ADDENDUM NO. 2

Westside Library Relocation Project

Addendum #2

Westside Library Expansion Project

& STOREFRONT

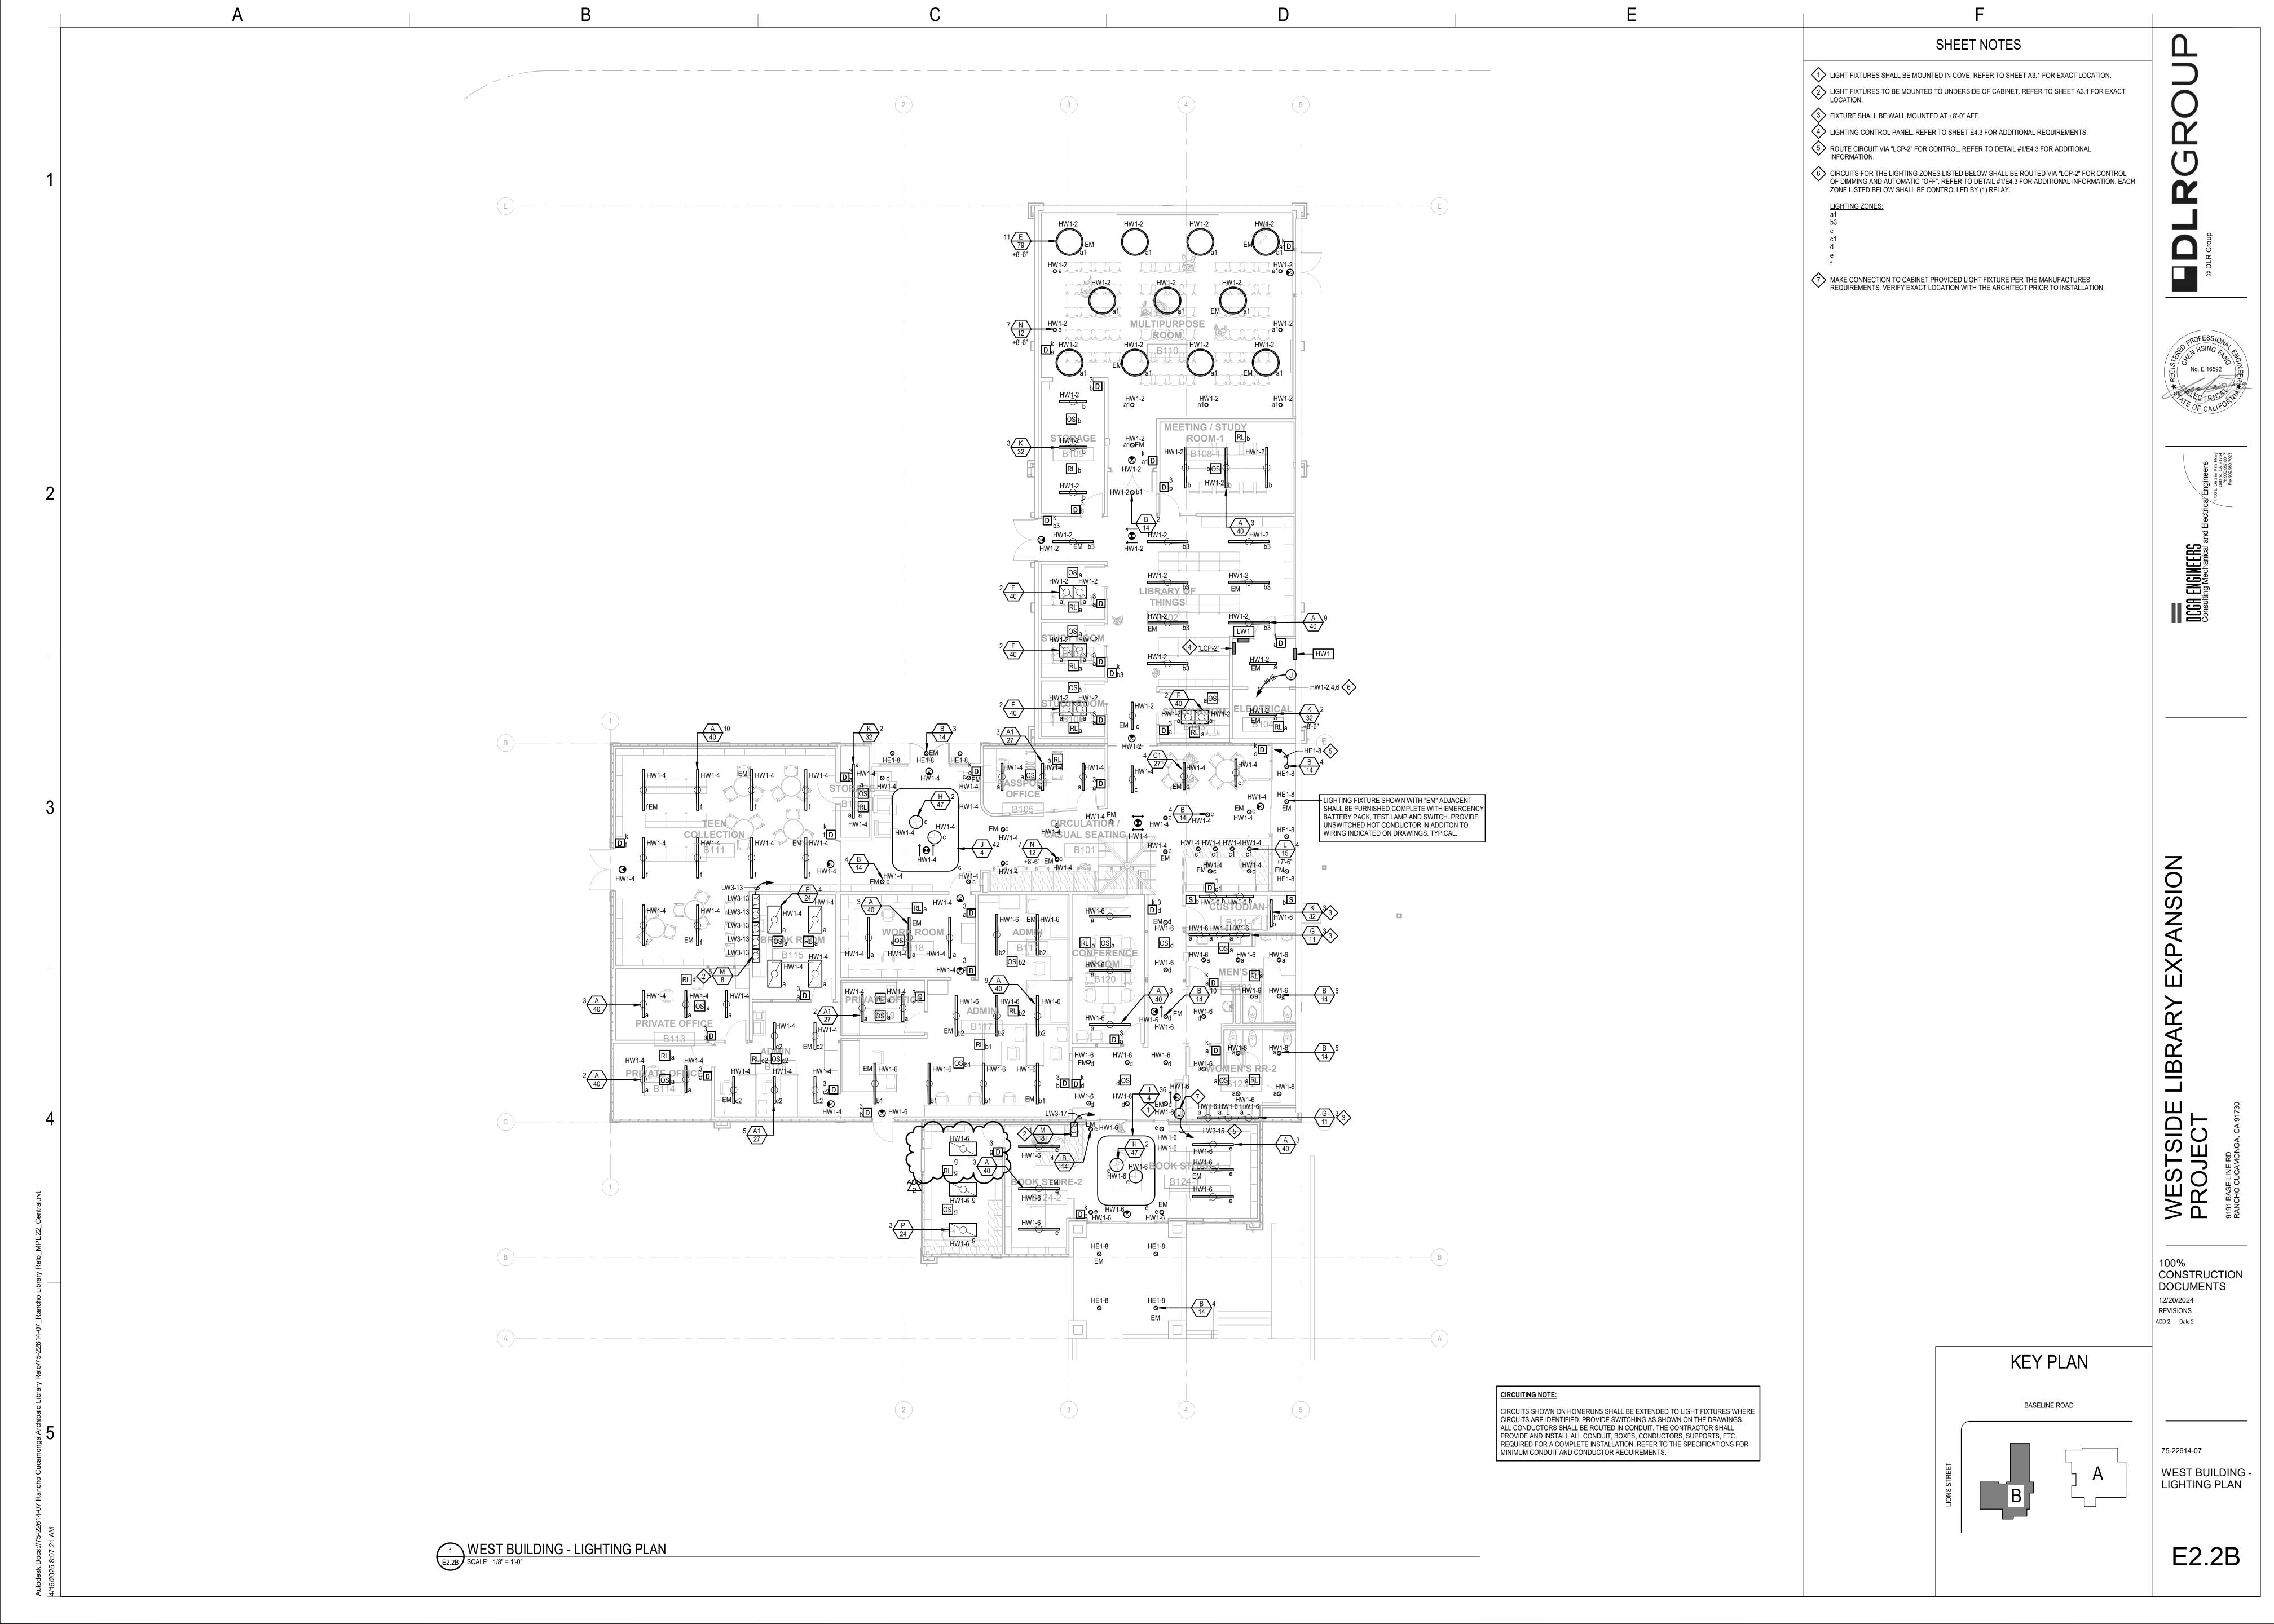
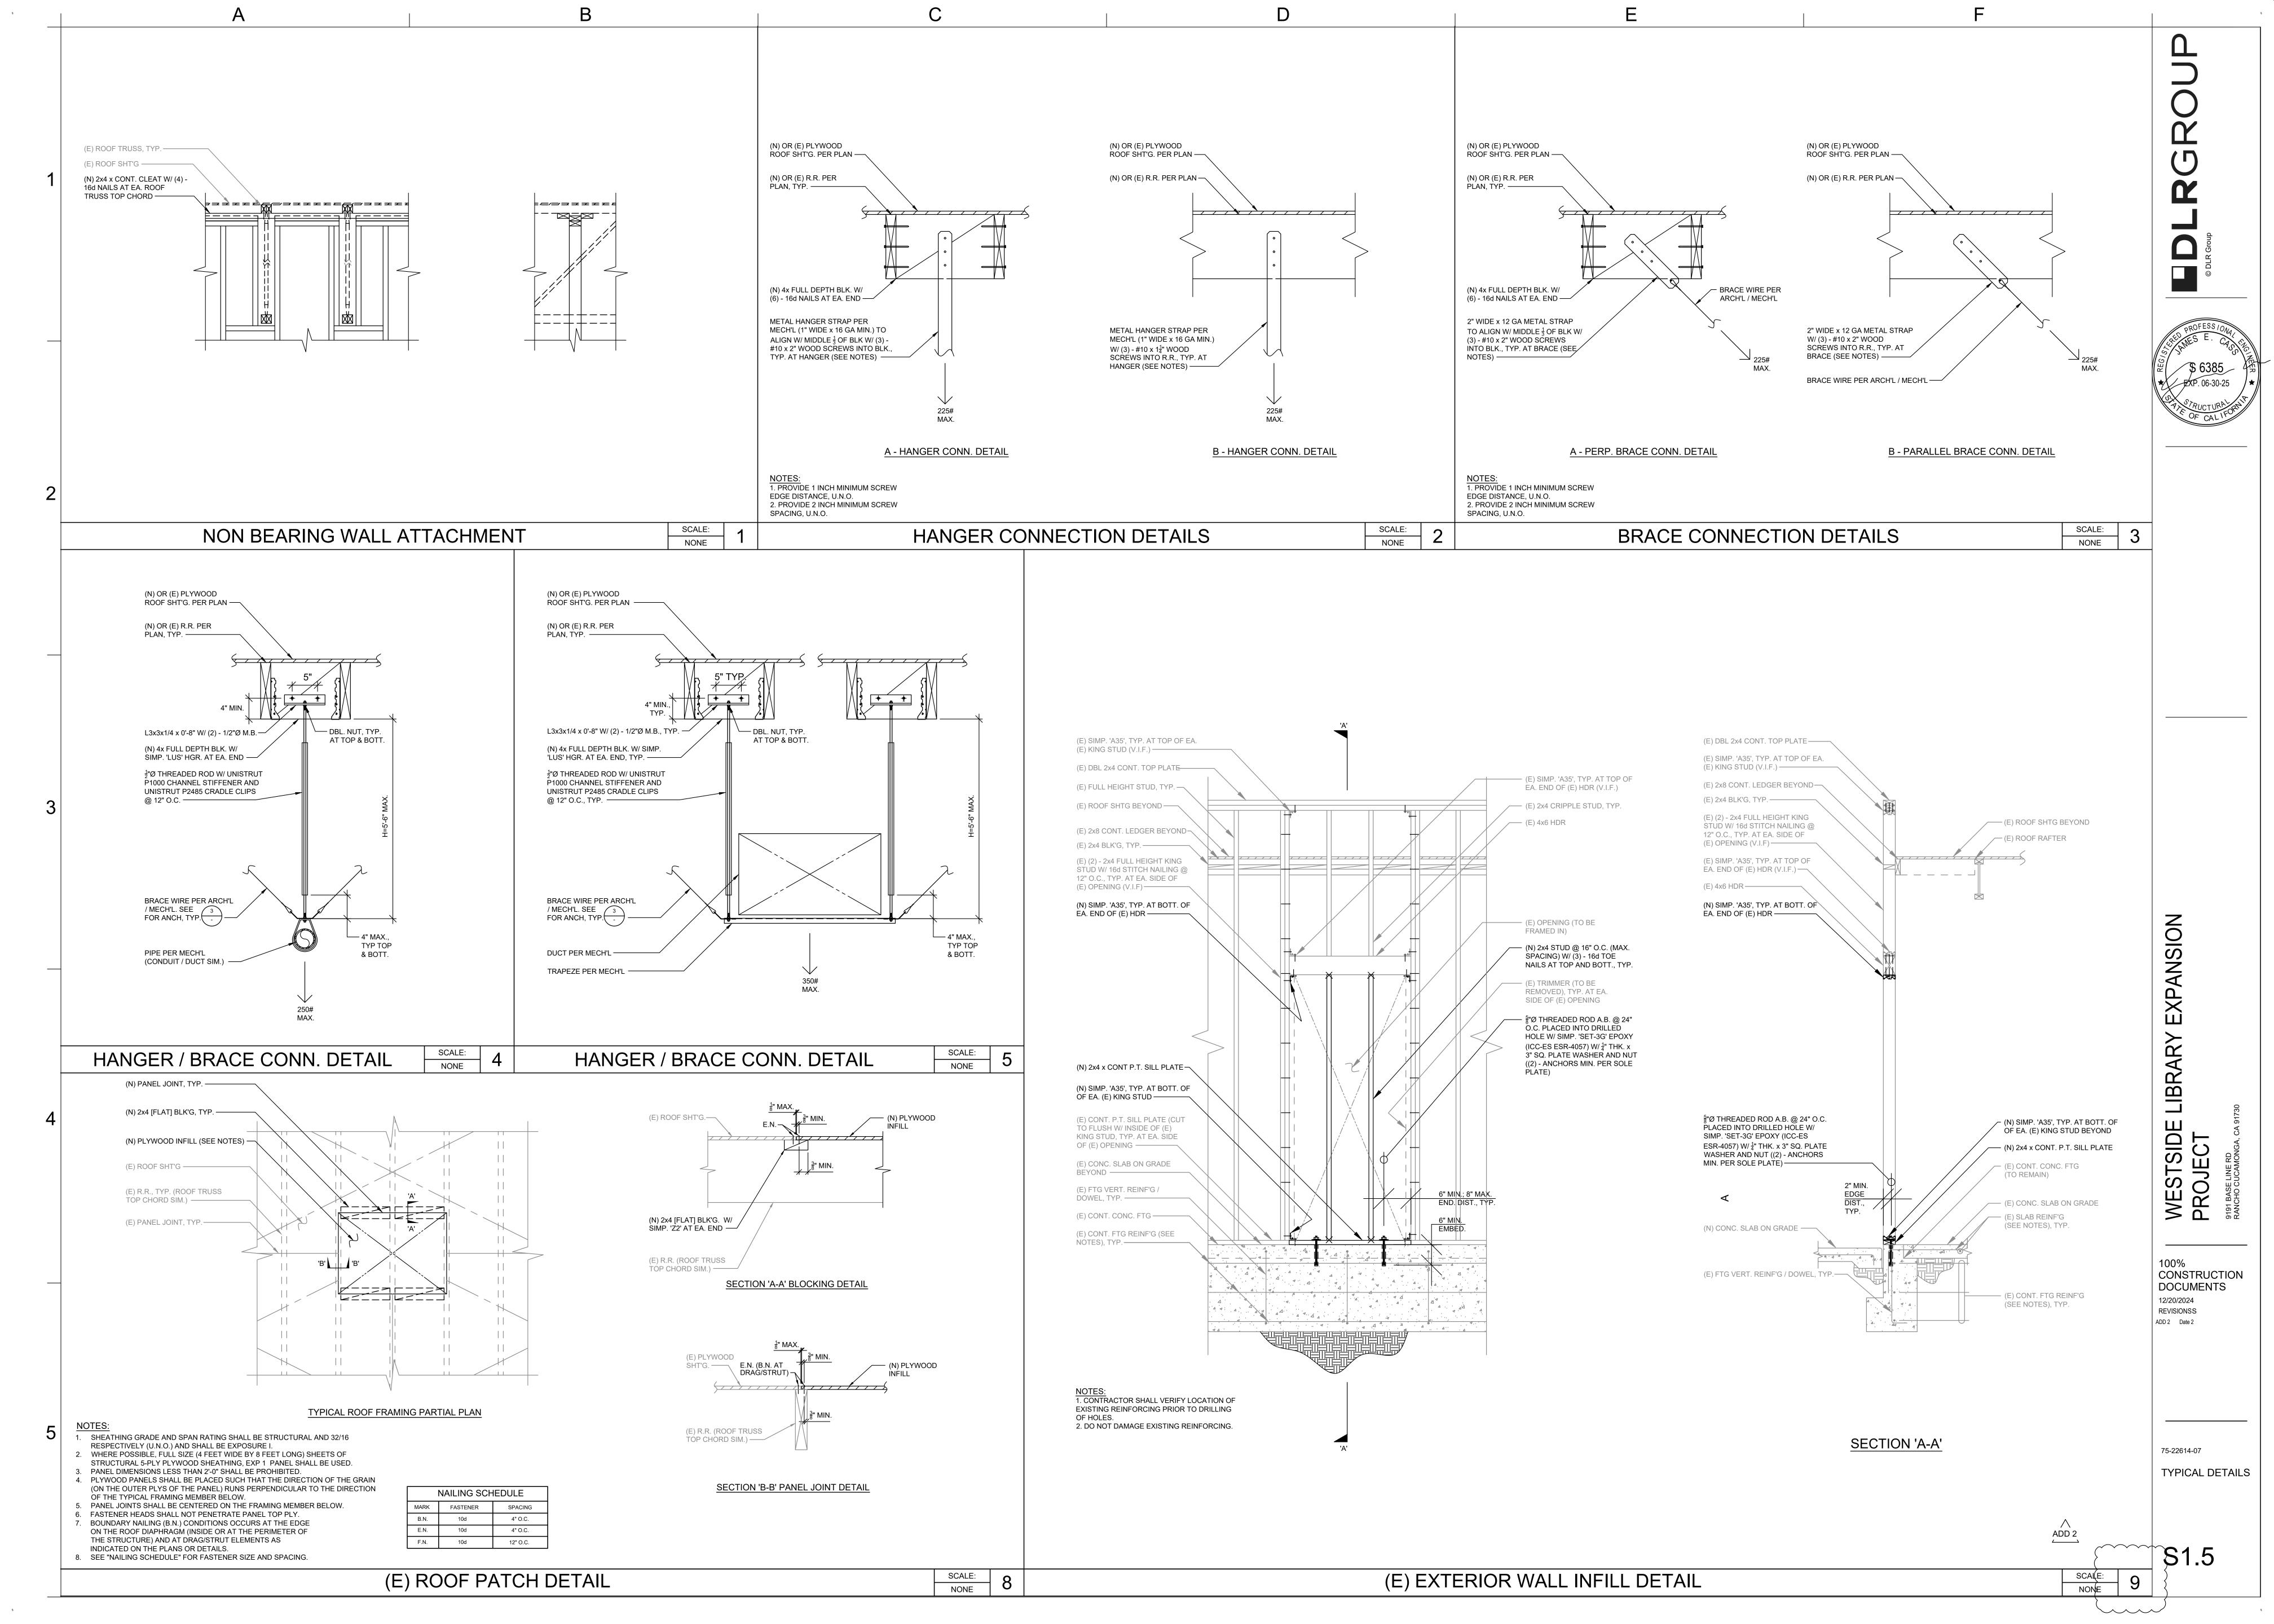
ITEM A-2.08 SHEET A8.1 – DOOR SCHEDULE & STOREFRONT ELEVATIONS

1. REMOVING DOOR B124C FROM SCHEDULE.
